**Presentation on the Jackson Bluff Dam Spillway Project**

**RE: Surface Water Management Application 04-2009-0006 I**  
**Jackson Bluff Dam Spillway Modification – Gadsden County**

Re: City of Tallahassee – Corn Hydroelectric Generating Facility  
Spillway Modification Project – Application 04-2009-0006 I  
Request for Information dated October 19, 2009

RE: City of Tallahassee – Corn Hydro Spillway Modification  
Application 20-0296182-001-DF - Request for Additional Information – Item #3

City of Tallahassee  
 C. H. Corn Hydro Facility  
 Attachment 1 - Inflow vs. Outflow and Tailwater Elevation

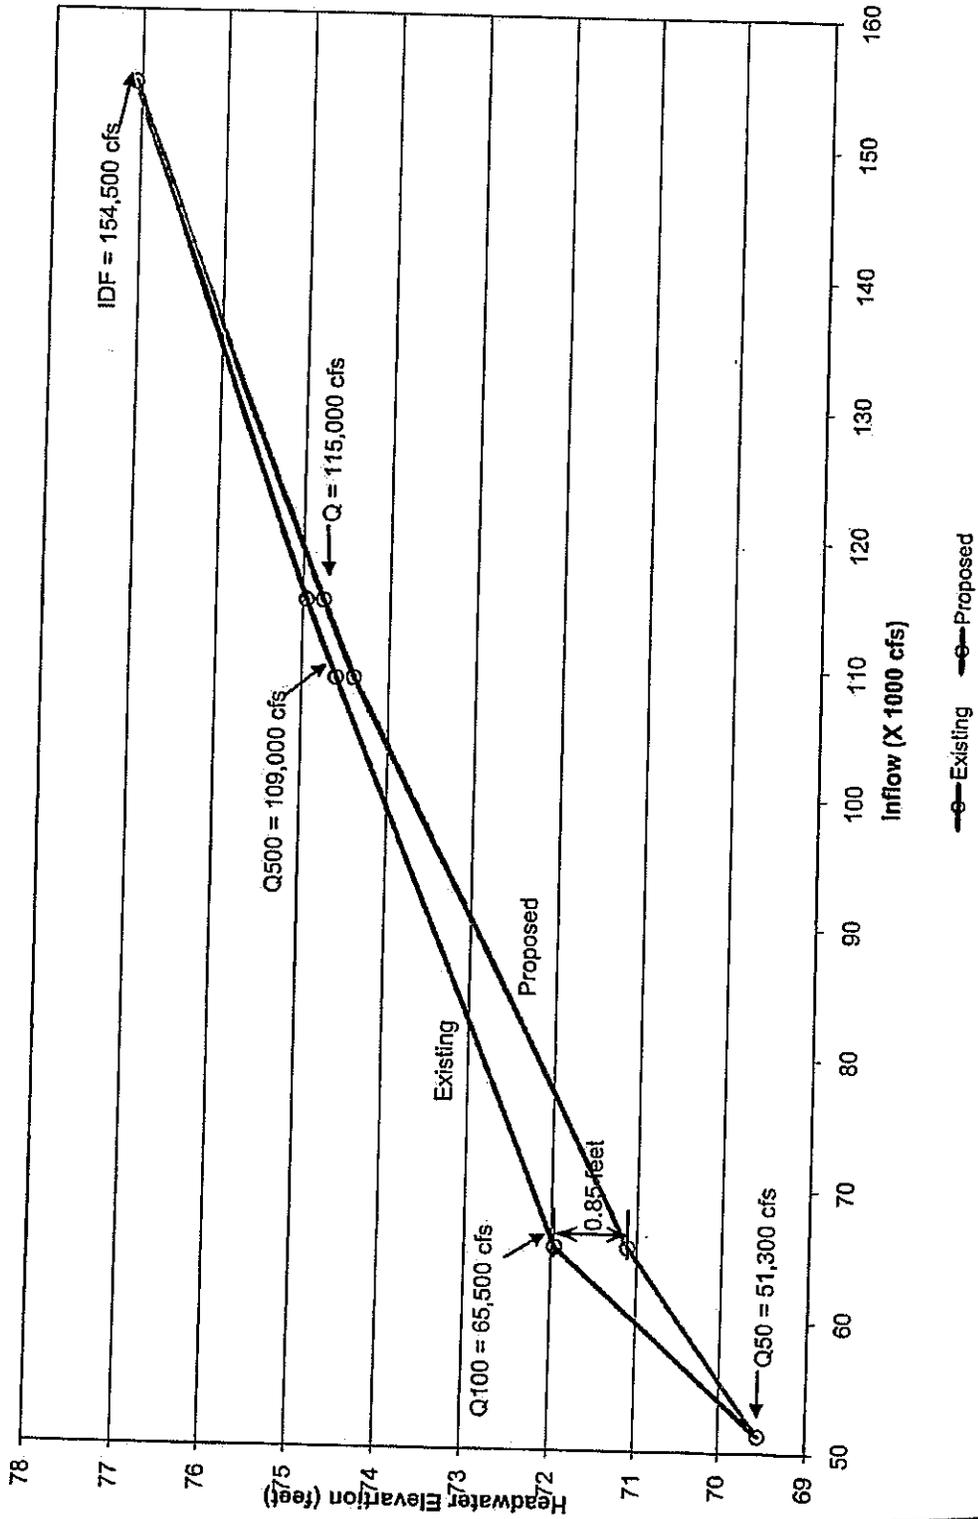
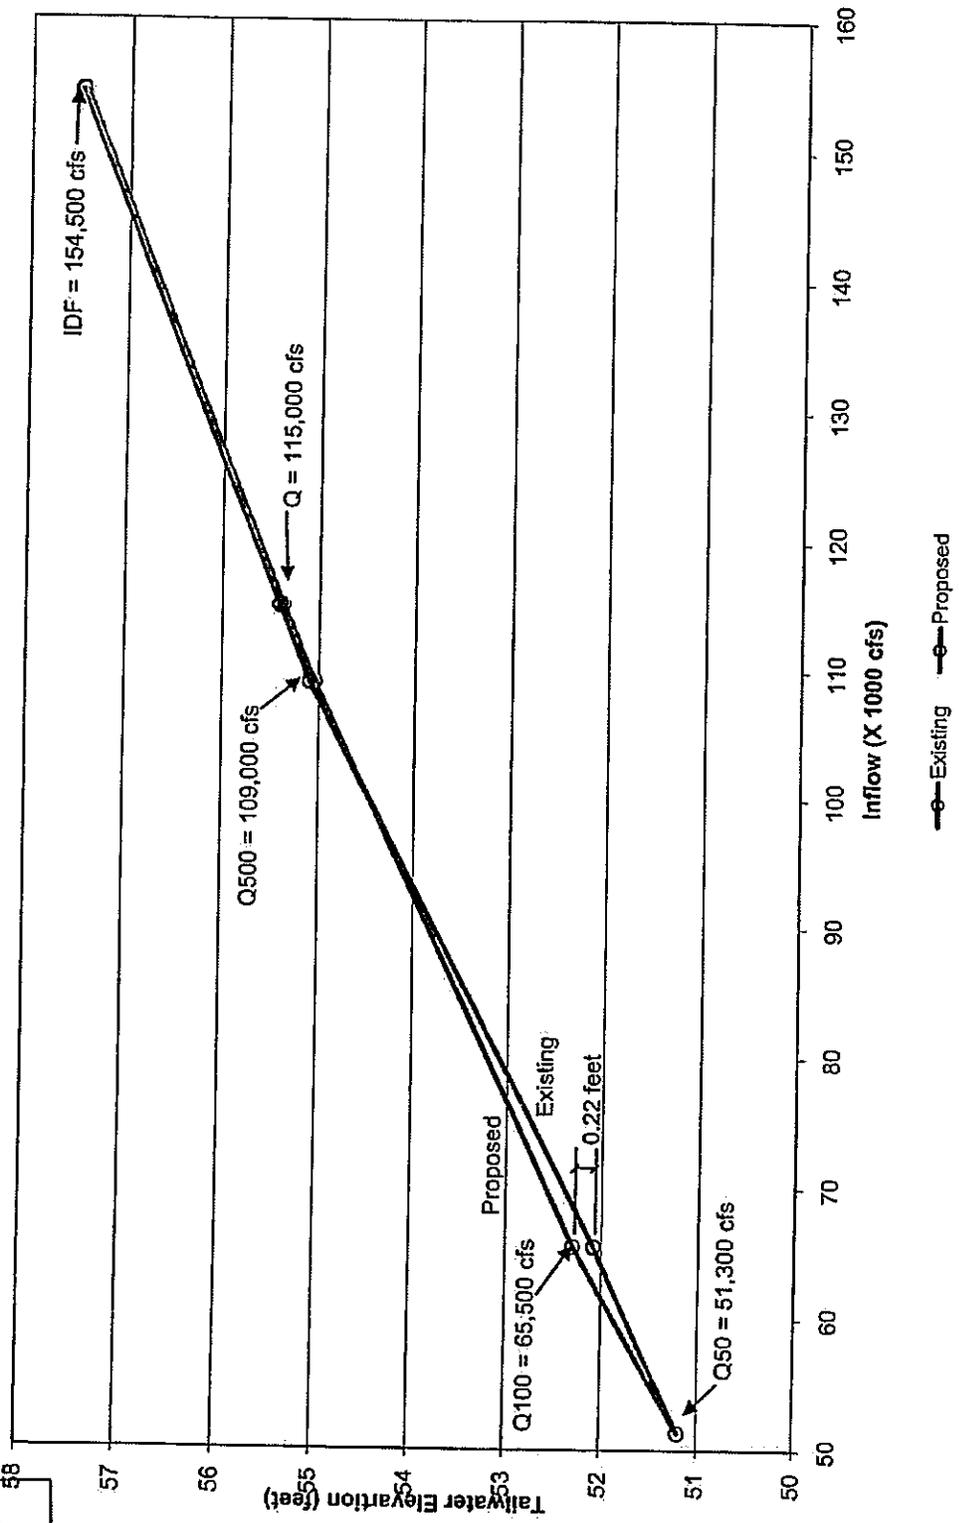
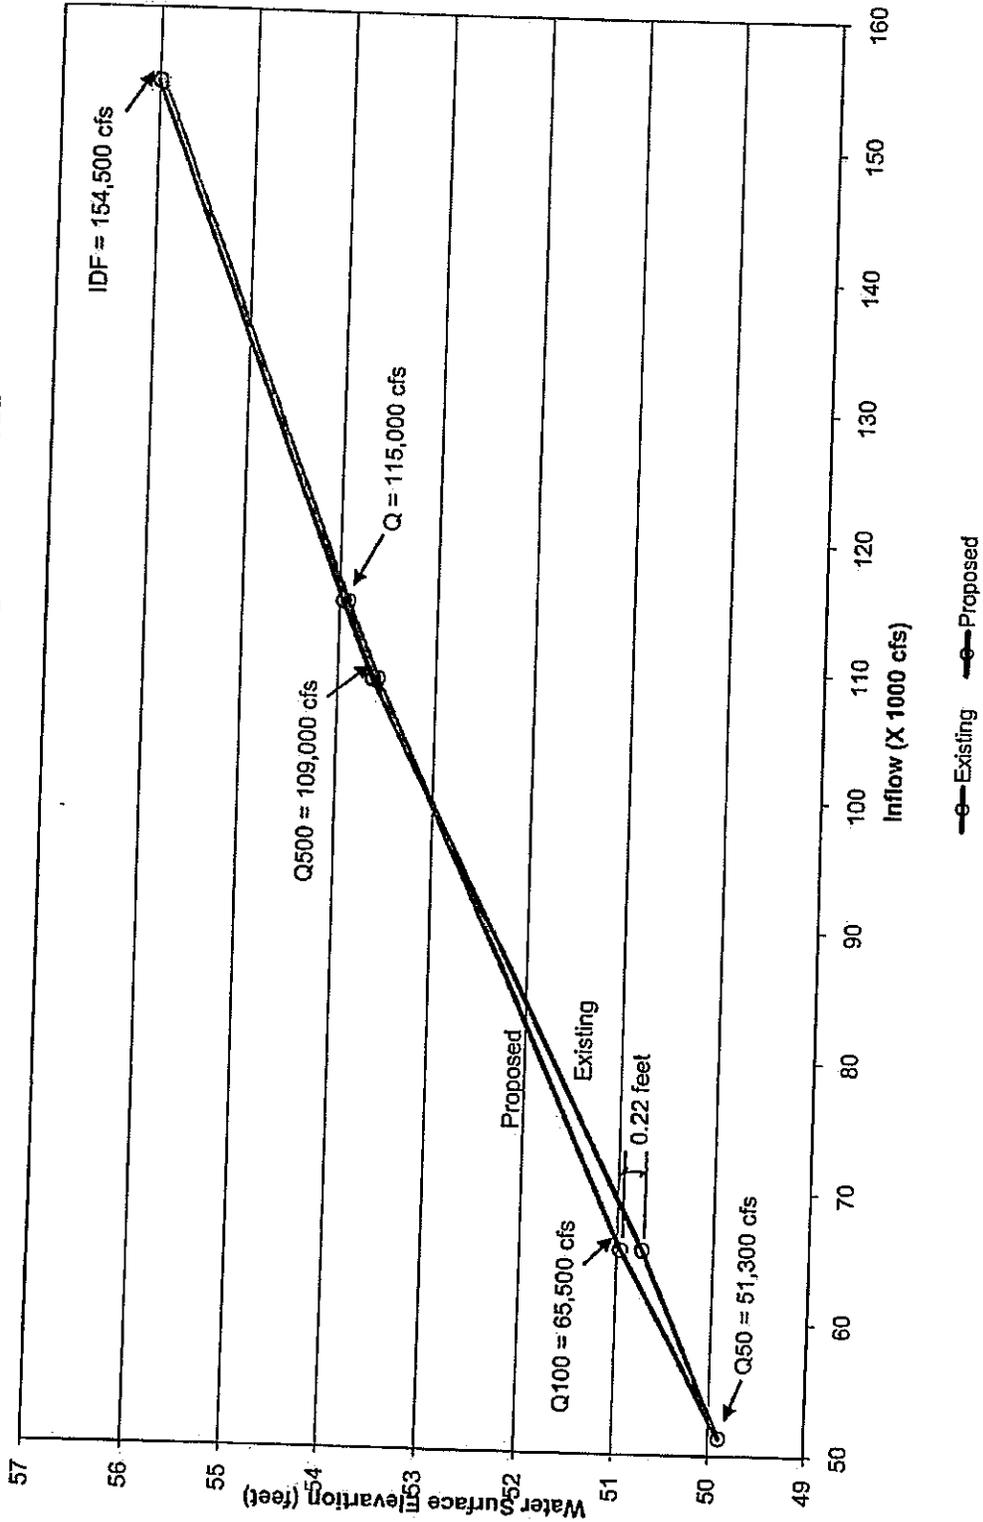
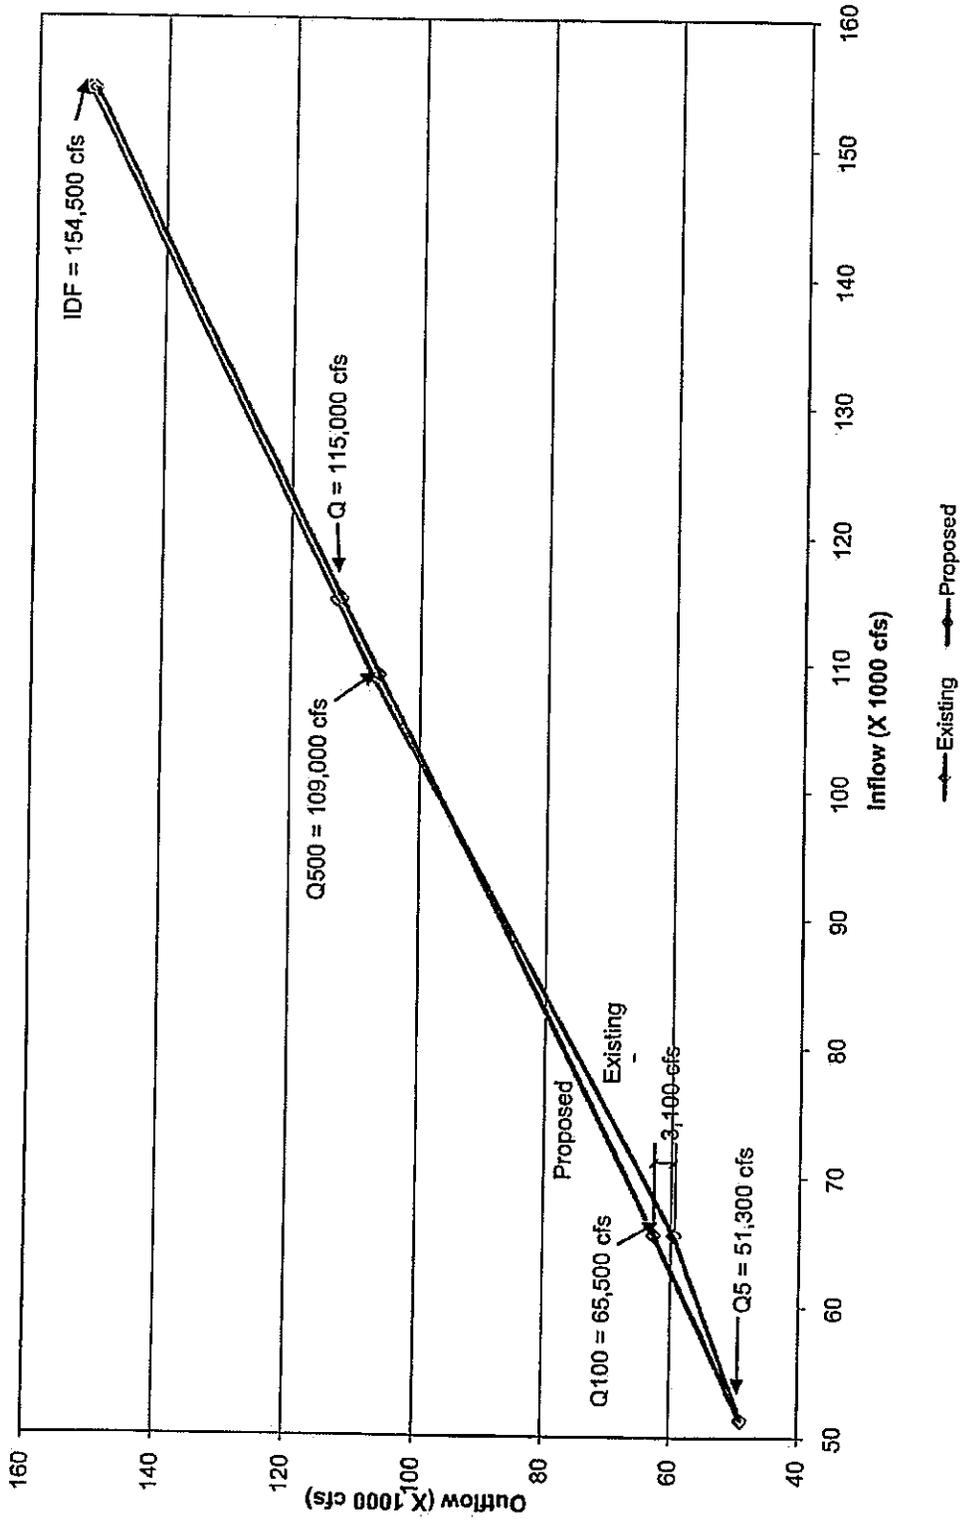
As you know, we recently received an objection letter concerning your project's proposed lowering of the spillway. Please provide a letter clearly stating and justifying that the lowering of the existing invert of the spillway by 2.5 feet will not increase the potential for flood damage to the houses downstream of the dam.

Attached you will find a set of graphs (Attachment 1) prepared by the City's engineer that depicts maximum river elevations at three locations and the maximum dam outflow versus various inflows to Lake Talquin.<sup>1</sup> The river level elevations are in feet MSL and the flows are shown as 1000 cubic feet per second (cfs). The three locations are the headwater of the dam, the tailwater, and Crooked Road, which is located approximately 0.7 miles downstream from the dam. These graphs compare the maximum dam outflow and river elevations for the existing design and the new spillway design.

The first graph in Attachment 1 shows that the maximum outflow for the proposed new spillway design is slightly lower than that for the existing design under most of the inflow conditions except for the 100-year flood. Under the 100-year flood, the maximum outflow for the proposed new spillway design is approximately 3,100 cfs higher than that for the existing design, which results in an increase of 0.22 feet in the maximum river elevations at both the tailwater (graph 3) and Crooked Road locations (graph 4). However, any increase in the downstream river level does not occur until it is above El. 51 (see Attachment 2), which is 4.3 feet above the published flood stage of 22 feet (46.69 feet msl).

The second graph in Attachment 1 shows that the headwater elevation for the existing design is either the same or higher than that for the proposed new spillway design under all inflow conditions. Under the 100-year flood, the difference is the greatest, which is 0.85 feet. For the existing design, the headwater elevation is at El. 72, which is only 0.3 feet
